RBW6305G11331-3G MAIN GEAR BOX INPUT PINION RING NUT WRENCH

WORK ORDER NON-CONFORMANCE / UPDATE

RBW6305G11331-3G-07 LUGS

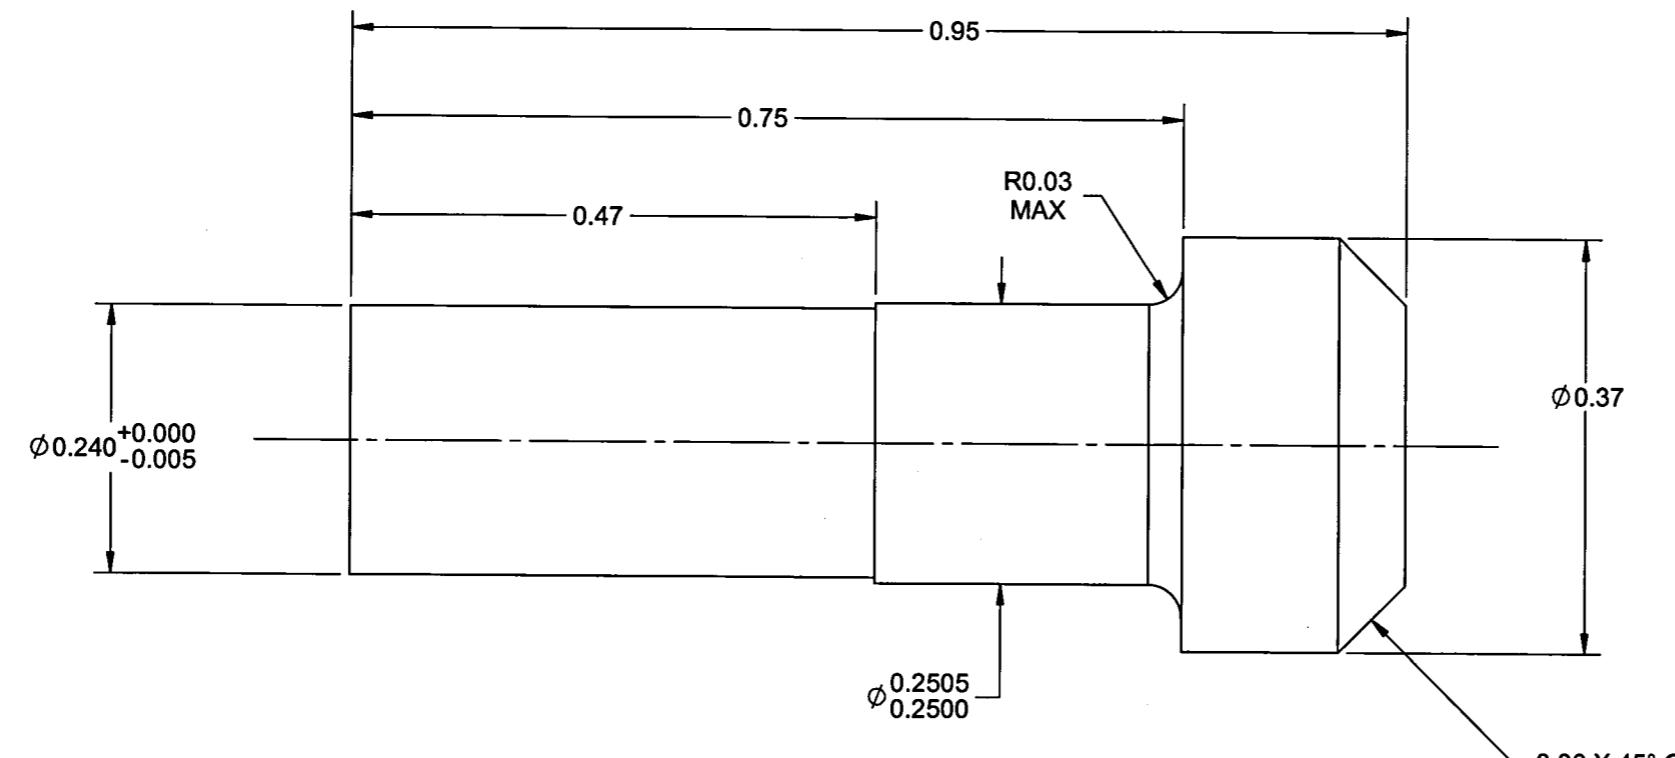
C	TEMPLATE UPDATED, DIMENSION .242 +.001/-0 CHANGED FOR .2500/.2505, DIMENSION .240 +/-.002 CHANGED FOR .240 +0/-0.005			18-538	VM
REV.	DESCRIPTION			ECN #	BY
DESIGN	VM	DART AEROSPACE LTD HAWKESBURY, ONTARIO, CANADA			A
DRAWN	VM 04/17/2018				
CHECKED	VM 04/17/2018	TOOL PART #			C
MFG. APPR.	DP 04/18/2018	RBW6305G11331-3G			SHEET 5 OF 8
APPROVED	ML 04/24/2018	TITLE MAIN GEAR BOX INPUT PINION RING NUT WRENCH NTS			SCALE
DATE 4/24/2018		COPYRIGHT © 2018 BY DART AEROSPACE LTD THIS DOCUMENT IS PRIVATE AND CONFIDENTIAL AND IS SUPPLIED ON THE EXPRESS CONDITION THAT IT IS NOT TO BE USED FOR ANY PURPOSE OR COPIED OR COMMUNICATED TO ANY OTHER PERSON WITHOUT WRITTEN PERMISSION FROM DART AEROSPACE LTD.

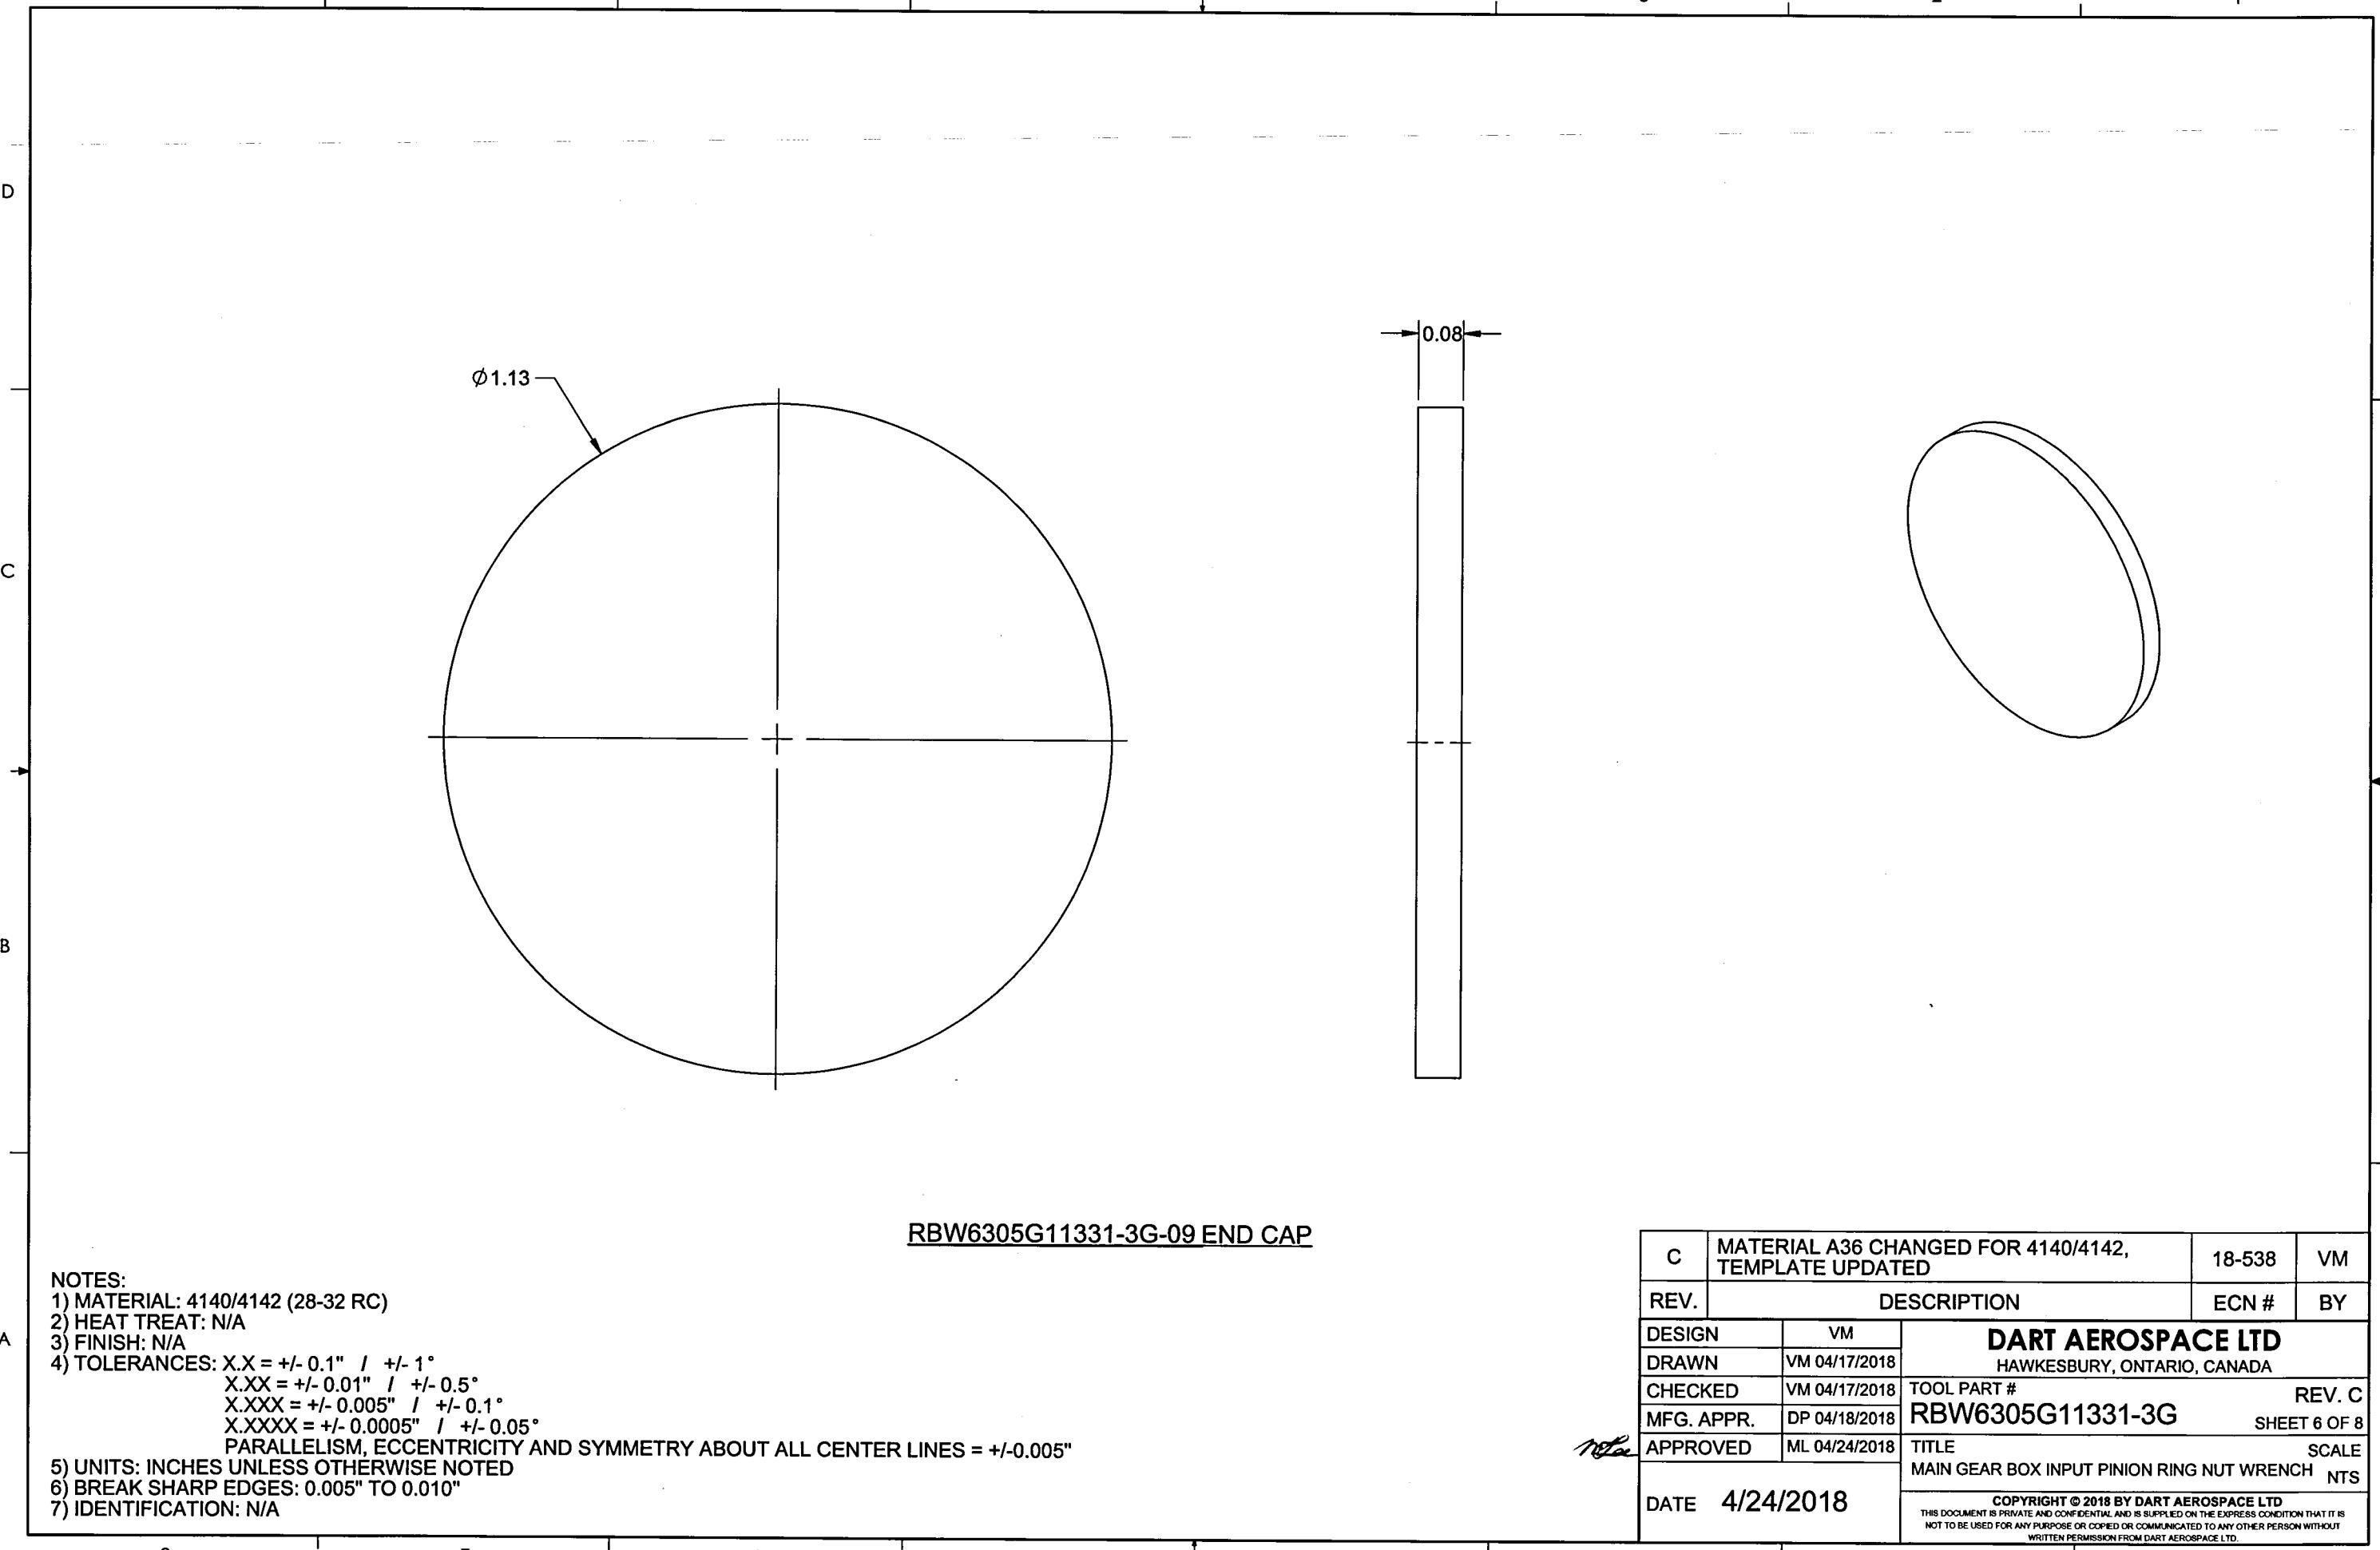
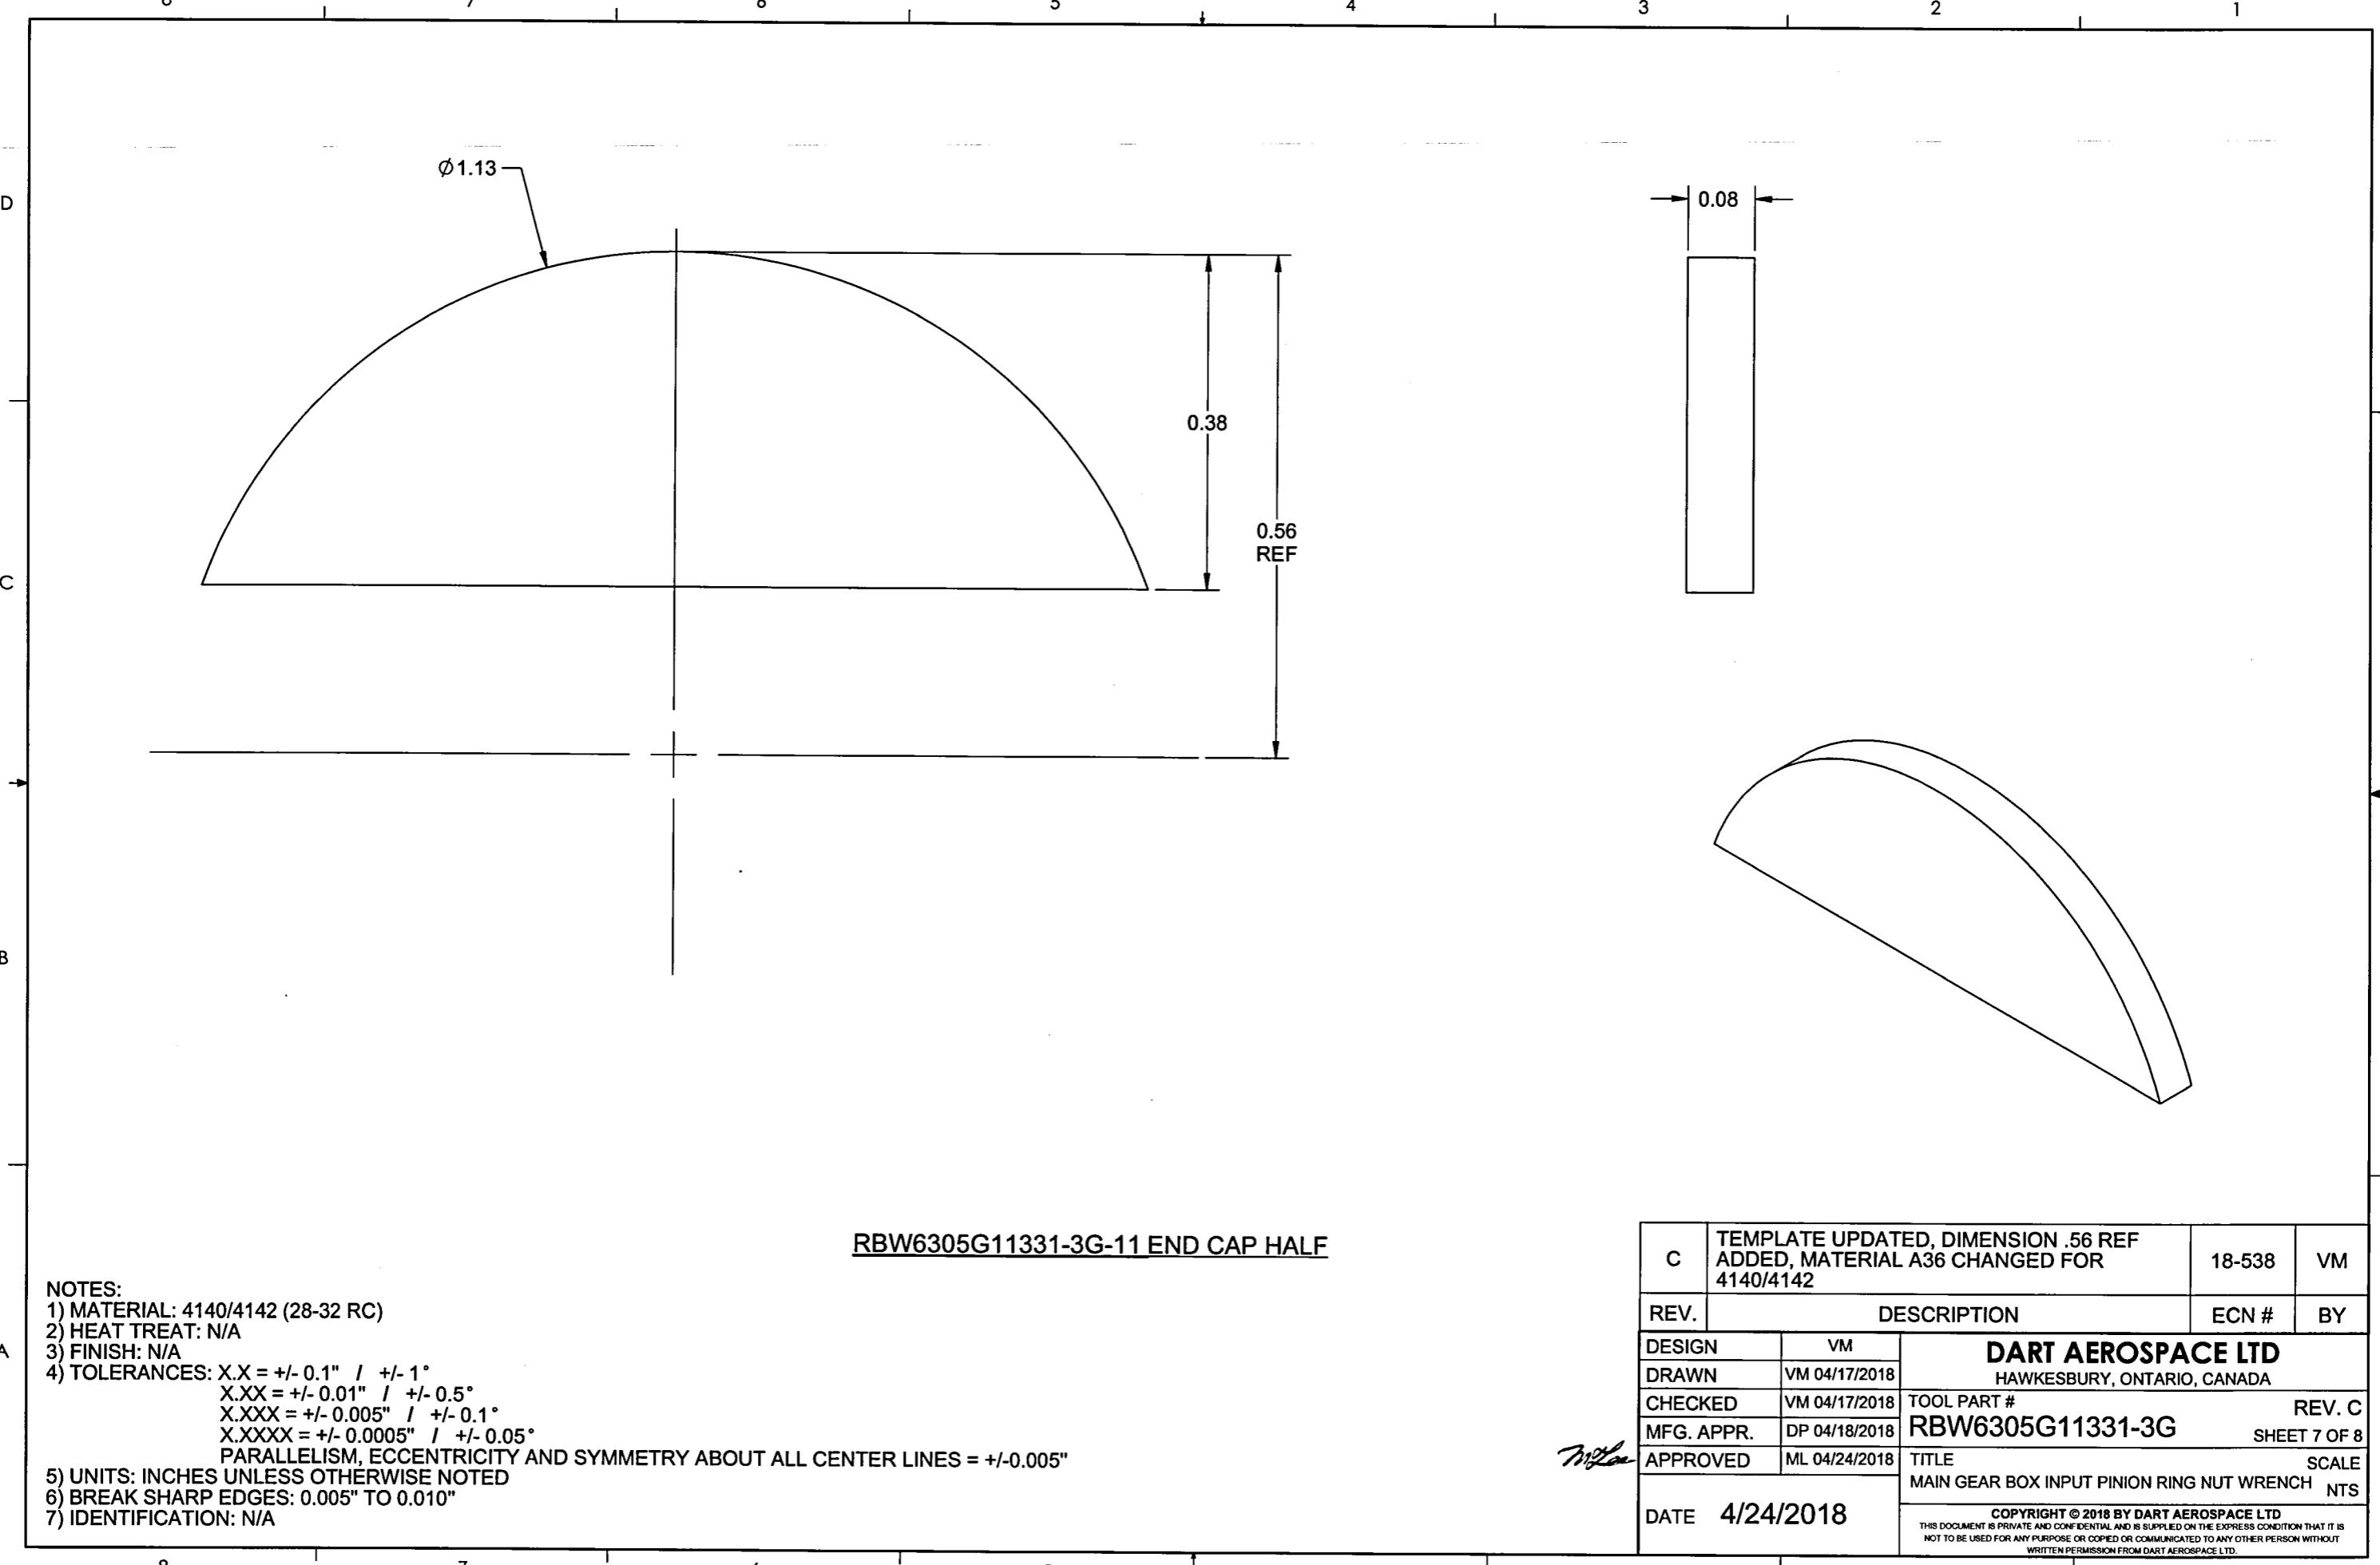
Description Work Order Deviation	Disposition	Completed By
MATERIAL TYPE TO BE CHANGED FOR - RBW6305G11331-3G-09 END CAP - RBW6305G11331-3G-11 END CAP HALF - REVISE MATERIAL FROM 4140/4142(28-32 Rc) TO 4130	- THIS DEVIATION IS ACCEPTABLE - THE FIT, FORM AND FUNCTION OF THE PART WILL BE AS ORIGINALLY INTENDED.	Lead hand / Supervisor Approval Verification QC / QA Coordinator Approval

RBW6305G11331-3G-13 SOCKET

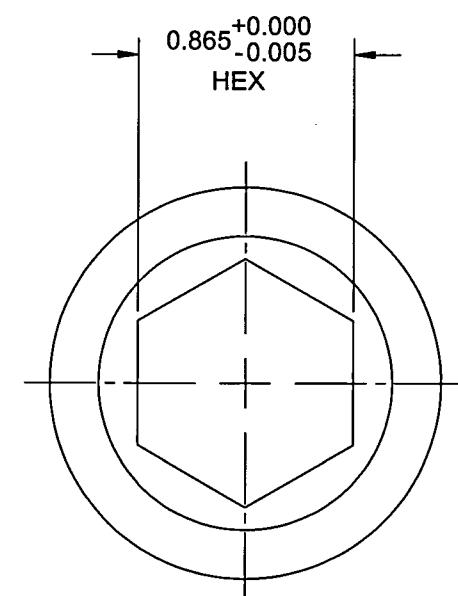
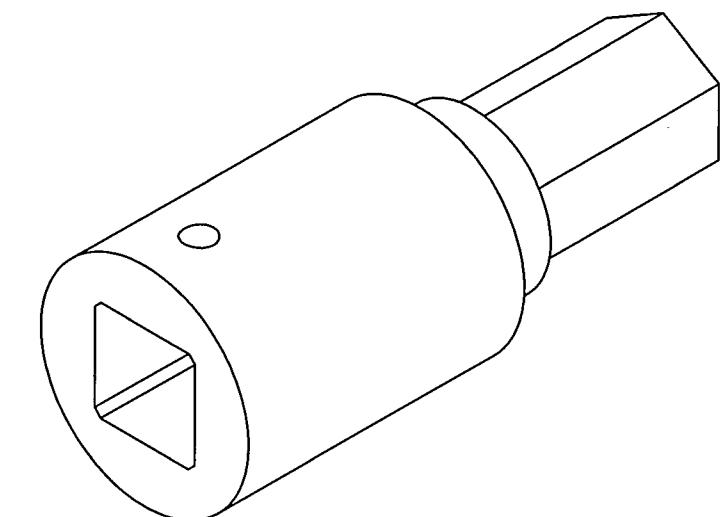
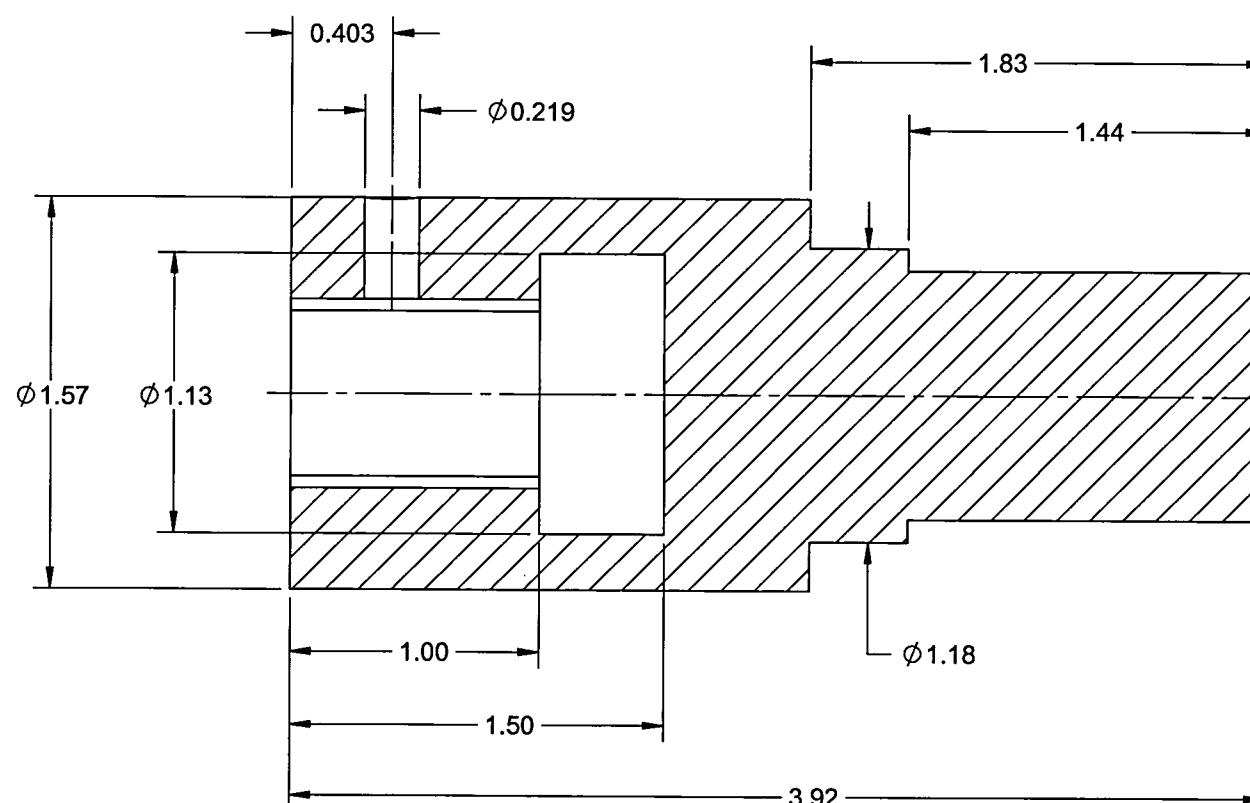
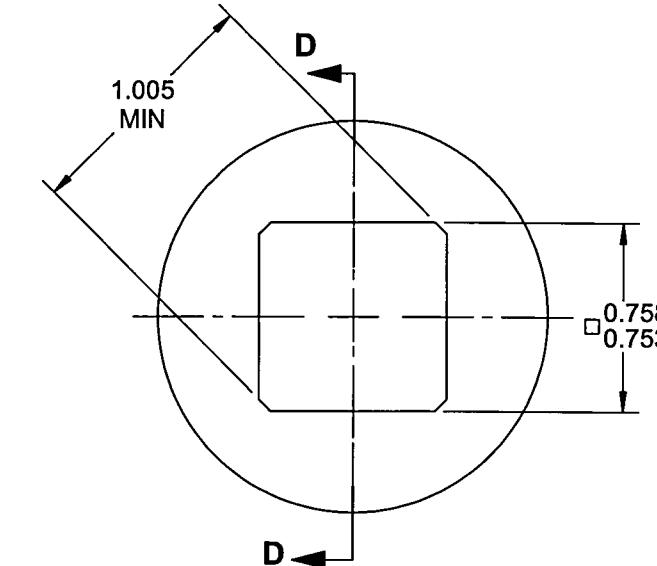
C	MISSING PART ADDED		18-538	VM
REV.	DESCRIPTION		ECN #	BY
DESIGN	VM			
DRAWN	VM 04/17/2018			
CHECKED	VM 04/17/2018	TOOL PART #		
MFG. APPR.	DP 04/18/2018	RBW6305G11331-3G	REV. C	
APPROVED	ML 04/24/2018	TITLE		
		MAIN GEAR BOX INPUT PINION RING NUT WRENCH		
		NTS		
	DATE	4/24/2018	COPYRIGHT © 2018 BY DART AEROSPACE LTD	
			THIS DOCUMENT IS PRIVATE AND CONFIDENTIAL AND IS SUPPLIED ON THE EXPRESS CONDITION THAT IT IS NOT TO BE USED FOR ANY PURPOSE OR COPIED OR COMMUNICATED TO ANY OTHER PERSON WITHOUT WRITTEN PERMISSION FROM DART AEROSPACE LTD.
